**PLANNED UNIT DEVELOPMENT  
& SUBDIVISION STAFF REPORT****Date: June 21, 2018**

<b><u>DEVELOPMENT NAME</u></b>	Garden Trace Subdivision, Resubdivision of Lots 7 & 8
<b><u>SUBDIVISION NAME</u></b>	Garden Trace Subdivision, Resubdivision of Lots 7 & 8
<b><u>LOCATION</u></b>	7 Garden Trace (East terminus of Garden Trace)
<b><u>CITY COUNCIL DISTRICT</u></b>	District 7
<b><u>PRESENT ZONING</u></b>	R-1, Single-Family Residential District.
<b><u>AREA OF PROPERTY</u></b>	2 Lots / 2.6± Acres
<b><u>CONTEMPLATED USE</u></b>	Subdivision Approval to adjust an interior lot line between two (2) legal lots of record and Planned Unit Development Approval to amend a previously approved Planned Unit Development to allow a private street subdivision.
<b><u>TIME SCHEDULE FOR DEVELOPMENT</u></b>	Not provided.

# SITE PLAN

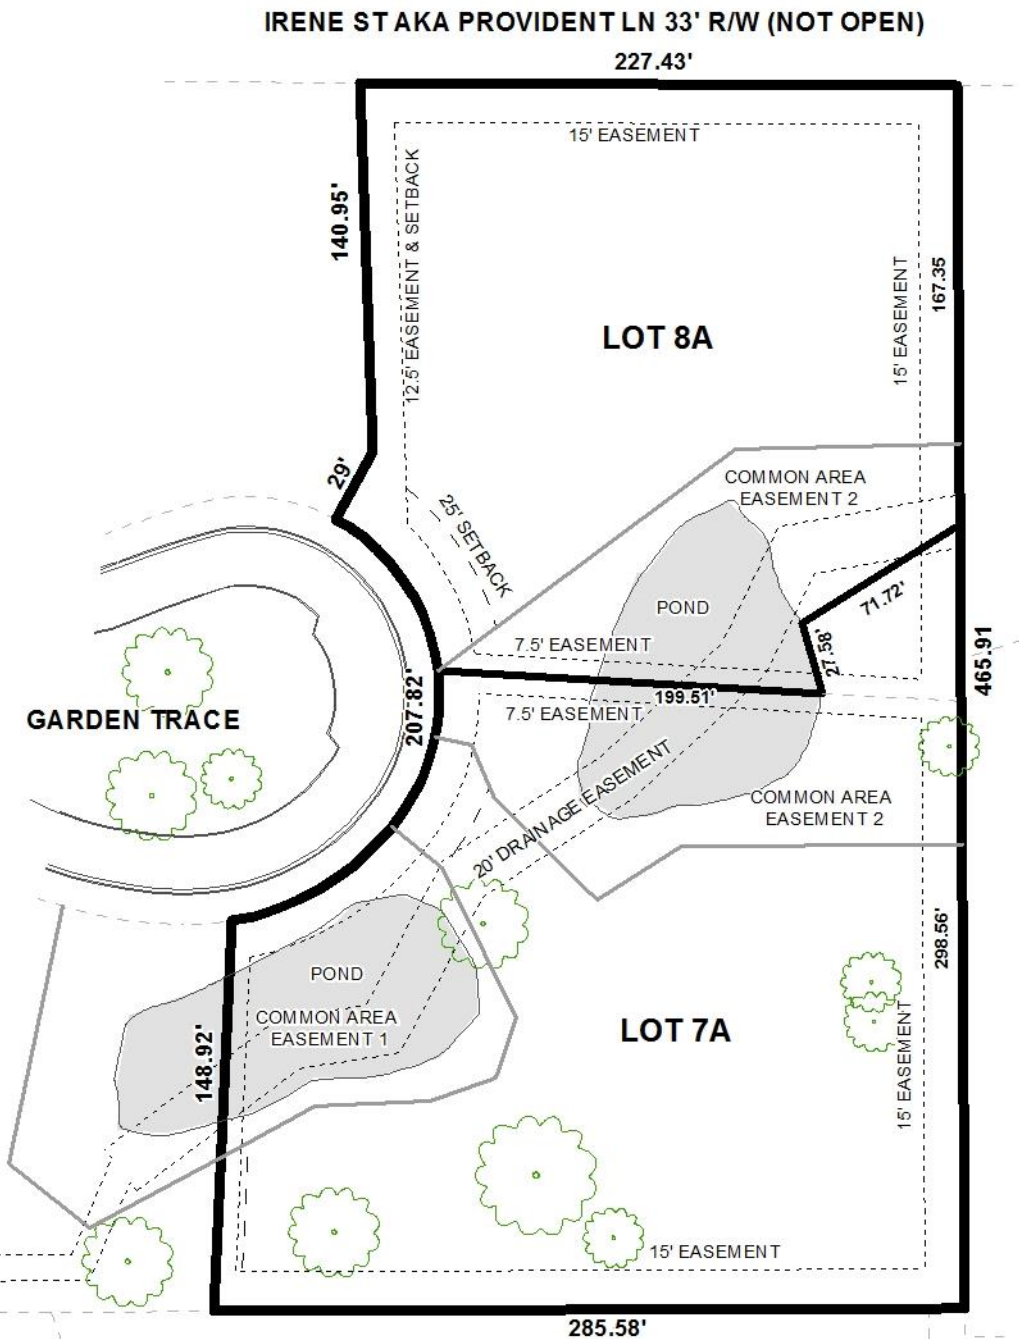
It should be noted that the PUD site plan also illustrates that Lots 1 and 5 have frontage along Tuthill Lane, a minor street without curb and gutter requiring a 60' right-of-way width; and, that Lot 4 has frontage along the unopened right-of-way of the proposed College Lane, the width of which is 33'. Adequate right-of-way is illustrated along the proposed College Lane, but the site plan illustrates a 45' right-of-way width along Tuthill Lane. Previous Subdivision and PUD Approvals only required dedication to provide 25' from the centerline of Tuthill Lane and, as such, if approved, the PUD site plan should be revised to illustrate this requirement.

Previous subdivision of the lots did not limit the amount of curb cuts permitted along Garden Trace, but a note on the plat states the size, design and location of all new curb cuts is to be approved by Traffic Engineering and conform to AASHTO standards. As such, retention of this note should be required on the Final Plat, if approved. This note should also be provided on the PUD site plan, if approved, with the exception of Lot 5, which was previously allowed two (2) curb cuts.

In coordination with previous Subdivision and PUD Approvals, an additional note should be placed on the PUD site plan stating Lot 1 is denied access to Tuthill Lane and that Lot 4 is denied access to College Lane.

The PUD site plan illustrates the aforementioned easements, as well as: 15' utility easements along the North property lines of Lots 1-6; 20' utility easements along the South property lines of Lots 1-4; a 15' utility easement along the South property line of Lot 5; a 10' drainage easement along the South property line of Lot 6; 15' utility easements along the West property lines of Lots 1 and 5; a 15' utility easement along the East property line of Lot 4; and 7.5' drainage and utility easements between Lots 1 and 2, between Lots 2 and 3, between Lots 3 and 4, and between Lots 5 and 6; and a common area easement to the East of Lot 6. As such, if approved, a note should be placed on a revised site plan stating no structures shall be constructed in any easement.

A note has been placed on the plat stating that the maintenance of all common areas and common area easements, including detention ponds, is the responsibility of the property owners and not the City of Mobile. This note should be retained on the Final Plat, if approved. If approved this note should also be placed on a revised PUD site plan.

A note on the previously approved Subdivision plat stated that sidewalks would be required along all street frontages at the time of development. In coordination with the previous Subdivision Approval this note should be provided on the Final Plat, as well as on the PUD site plan, if approved.

Finally, while the private Garden Trace is already developed, a note should nevertheless be provided on both the Final Plat and PUD site plan, if approved, stating that the maintenance of the private street and all common areas are the responsibility of the property owners. An additional note should be placed on the Final Plat and the PUD site plan stating that, if the private street is not maintained to City standards inasmuch as it could ultimately be dedicated for public use and maintenance, then 100 percent of the cost of the improvements required to do so shall be assessed to the property owners at the time the private street is dedicated.

## DETAIL SITE PLAN

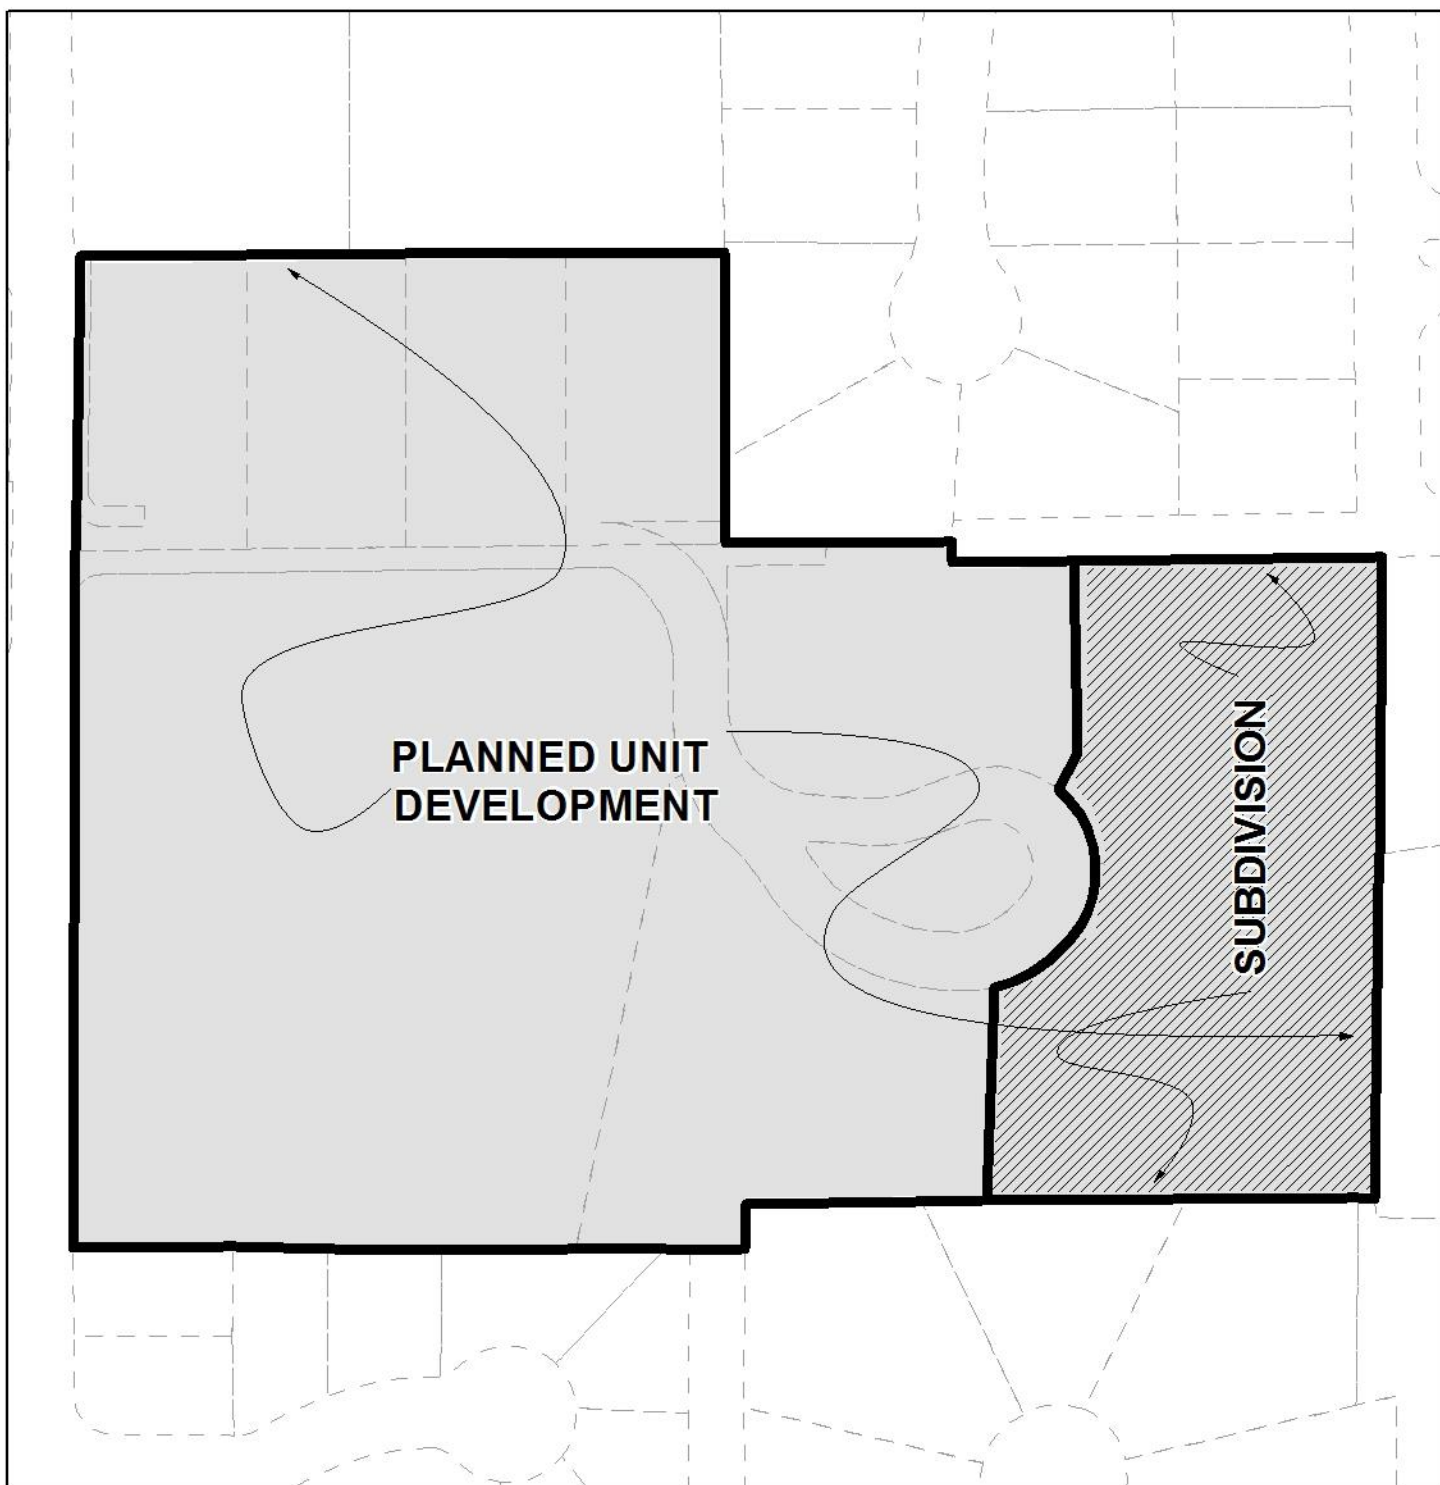
The preliminary plat and PUD site plan illustrate that the subject Lots, Lot 7A and Lot 8A, each have frontage on Garden Trace, a private street with a recorded 50' right-of-way width. Lot 8A also has frontage along the unopened right-of-way of the proposed Irene Street, also labeled as Provident Lane, the width of which is recorded as 33'. The right-of-way width along the unopened right-of-way of Irene Street is appropriately labeled on the plat and PUD site plan, but the right-of-way along Garden Trace is only illustrated on the PUD site plan. As such, if approved, revision of the plat to illustrate dedication sufficient to provide at least 25' from the centerline of Garden Trace should be required.

A portion of the 25' minimum building setback line is illustrated along Garden Trace, but not along the unopened right-of-way of Irene Street. While the building setback line along the unopened Irene Street right-of-way was not a requirement of the previous subdivision of the site, it was a requirement along Garden Trace. As such, revision of the plat and PUD site plan to illustrate the 25' minimum building setback line along the entirety of each lot's frontage on Garden Trace should be required, if approved.

Multiple easements are illustrated on the plat, including: 15' drainage easements along the East property line of each lot; 15' utility easements along the South property line of Lot 7A and along the North property line of Lot 8A; 7.5' utility easements along the North property line of Lot 7A and along the South property line of Lot 8A; a 15' utility easement along the frontage of Lot 7A; a 20'± drainage easement extending from the West property line of Lot 7A to the East property

line of Lot 8A; and common area easements to the West of Lot 7A, and between Lots 7A and 8A. As such, if approved, a note should be placed on the Final Plat stating no structures shall be constructed in any easement.
